APPLICATION NO.	FILING DATE	FIRST NAMED INVENTOR	ATTORNEY DOCKET NO.	CONFIRMATION NO.
10/591,772	09/06/2006	Etienne Chapelain	8952-000014/US/NP	4467
27572	7590	07/19/2008		
HARNES, DICKEY & PIERCE, P.L.C.				
P.O. BOX 828				
BLOOMFIELD HILLS, MI 48303				
EXAMINER				
DIAZ, THOMAS C				
ART UNIT		PAPER NUMBER		
4171				
MAIL DATE		DELIVERY MODE		
07/09/2008		PAPER

# Office Action Summary

## **DETAILED ACTION**

**Above figures- Hiramitsu et al. steering assembly.**

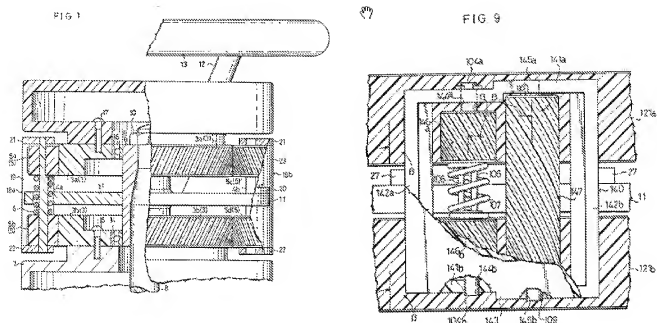
#### ***Regarding claim 1,***

Applicant claims a steering wheel (fig.1; Invention directed to a steering wheel, Title) having:

- A first gear element (fig.9, 121a),

- A second gear element (fig.9, 147),
- An anti-backlash gear which is mounted on one of first or second gear elements (fig.9, 146a; Prior art discusses motivation of suppressing backlash in col.2, lines 38-42, and col.13, lines 54-63; Examiner takes the position that this gear is "mounted on" gear 121a although it's not directly on top of it),

- The teeth of the anti-backlash gear configured so as to align substantially with gear on which it's mounted (fig.9, 146a; This is inherent since the gear teeth have to be substantially aligned in order for the device to function.)

- The anti-backlash gear being rotatably biased relative to the gear on which it is mounted towards a position where the teeth of the anti-backlash gear are displaced from the corresponding teeth of the gear element. (fig.9, 146a and 107; the spring biases gear 146a such that the teeth are displaced from the gear on which it is mounted, also explained in col.12, lines 10-21).
